Request for clarifications on Supplement C – 0101

Received from a specific group on July 16, 2001

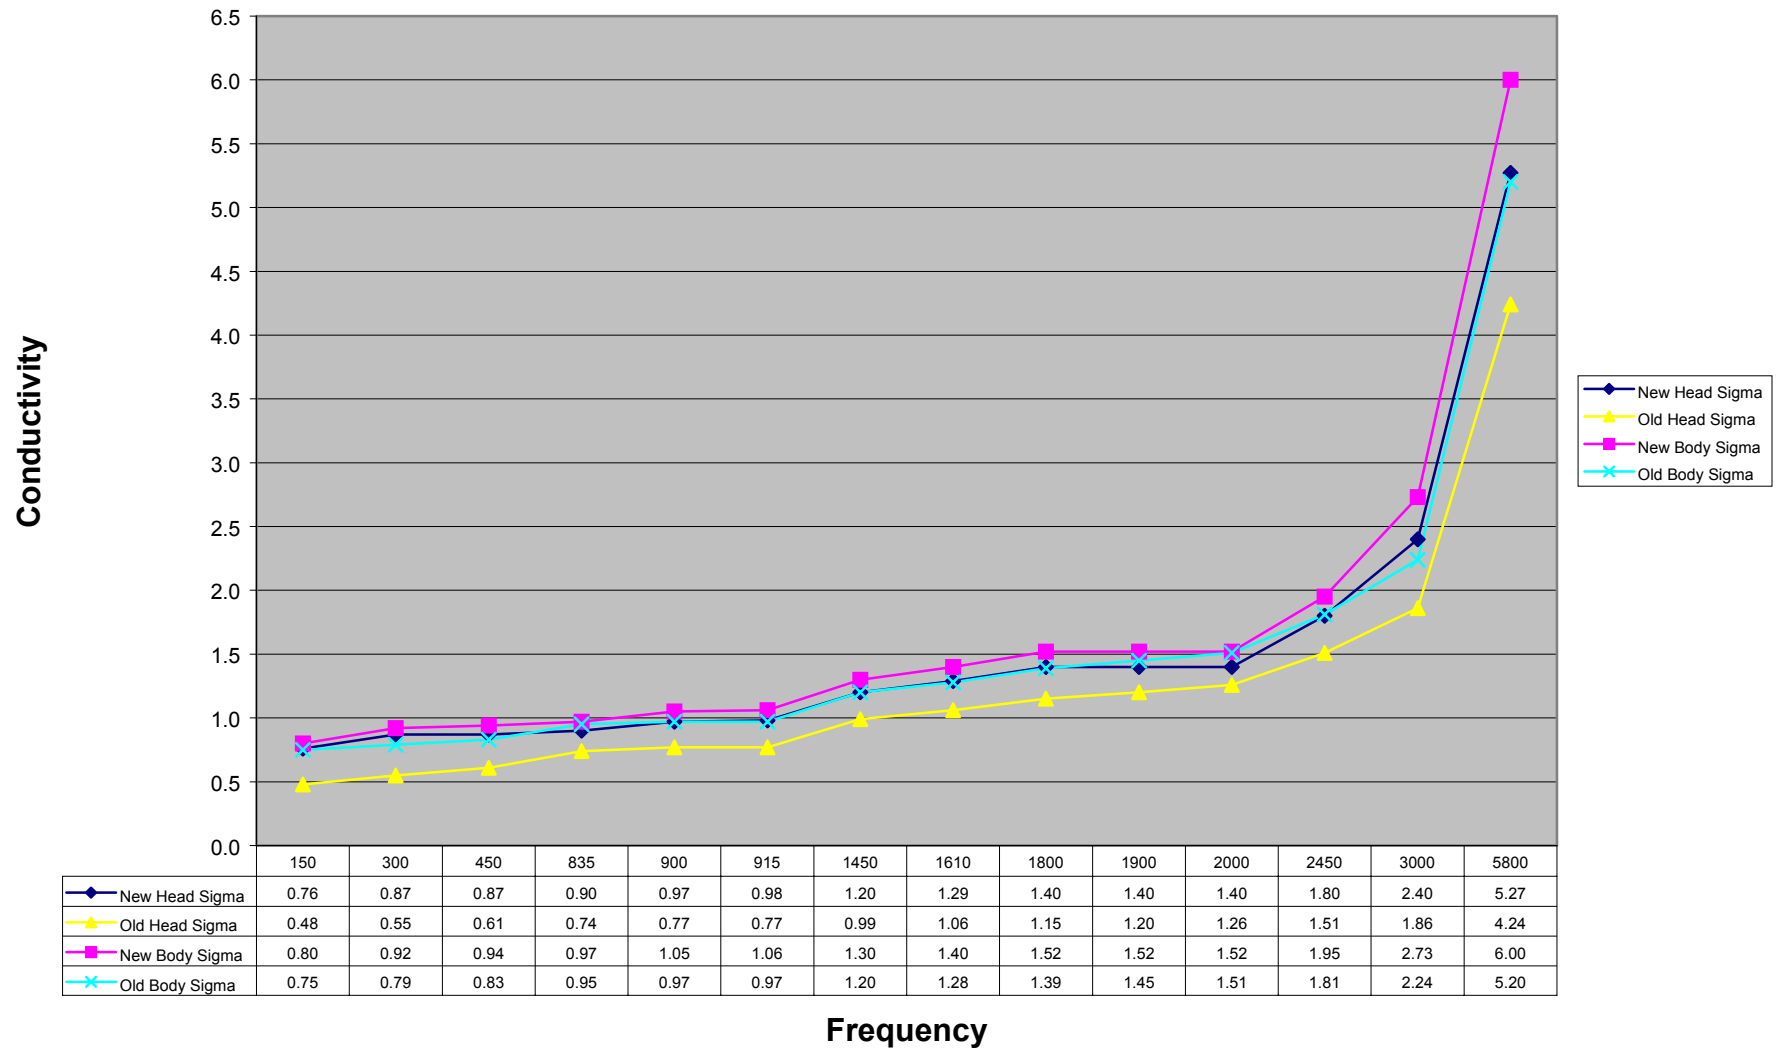
6. Dielectrics on page 37: how are the body tissue dielectric parameters derived? Would the body dielectric parameters in Supplement C be updated when new parameters are available from standards organizations (e.g. IEC, IEEE)?

Standardized tissue dielectric parameters for testing body (non-head) regions using homogeneous phantoms, similar to the head parameters developed by SCC-34, are currently unavailable. The IEC has been planning to address body-worn SAR test procedures, but has not yet started on an initial or preliminary draft. When standardized body dielectric parameters are available from standards organizations for testing SAR using homogeneous body phantoms and the parameters are applicable to the SAR requirements in the United States, the Commission will update Supplement C with such parameters.

The following have been considered in developing the body parameters indicated in Supplement C –

- i) SCC-34/SC-2 has head tissue parameters for 300 MHz – 3000 MHz only.
- ii) The SCC-34/SC-2 head parameters have been derived with numerical simulations using the various 4-Cole-Cole head tissue parameters in planar models to determine the appropriate parameters for testing in homogeneous phantoms.

- iii) Head parameters for 150 MHz and 5800 MHz have been extrapolated using the SCC-34/SC-2 homogeneous head parameters, with respect to the slope of the 4-Cole-Cole parameters for average white and gray matters (brain) in AL/OE-TR-1996-0037 (Reference [12] in Supplement C).

- iv) The curves for the dielectric parameters derived from the 4-Cole-Cole average white and gray matters are similar to the curves for the new SCC-34/SC-2 head parameters. These curves differ by a scale factor because the SCC-34/SC-2 parameters have been derived (selected) for use in a homogeneous phantom to estimate the exposure conditions in the heterogeneous tissues of the users, with little overestimation and no underestimation.

- v) The conductivity values of the SCC-34/SC2 head parameters (for homogeneous phantoms) are higher than the average muscle conductivity derived from the 4-Cole-Cole parameters. However, it has been known that muscle has higher conductivity than brain. Therefore, adjustments are needed for the muscle parameters to maintain the correct ratio of conductivity between the head and body parameters for making SAR measurements in

homogeneous phantoms. A similar rationale used to derive the SCC-34 head parameters has been applied to establish the conductivity values of body tissues in Supplement C. The ratio of average brain (white and gray matters) to average muscle conductivity obtained using the 4-Cole-Cole equations has been applied to scale the SCC-34 head conductivity to obtain appropriate body conductivity values for homogeneous phantoms. Other than being scaled by this ratio, the shape and slope of the resulting body conductivity curves are similar to the 4-Cole-Cole average muscle curves.

- vi) The average permittivity of different head tissues has been used, through computational modeling, to compute the highest conductivity required by the SCC-34 head phantom to make conservative SAR measurements. The average dielectric constant for parallel and transverse muscle parameters from the 4-Cole-Cole equation is about 2% lower than the higher of these two values. Since it is not clear what types of tissues should be included to derive body tissue parameters, the higher of the two muscle dielectric constant values (2% difference) has been used for body tissue.
 - vii) Relevant plots are attached at the end of this document.
7. Dielectric properties should be within 5% of the target values indicated in the table on page 37. There appears to be a conflict between this and the recommendation that the parameters be within 5% of the values used in the dipole reference measurement.
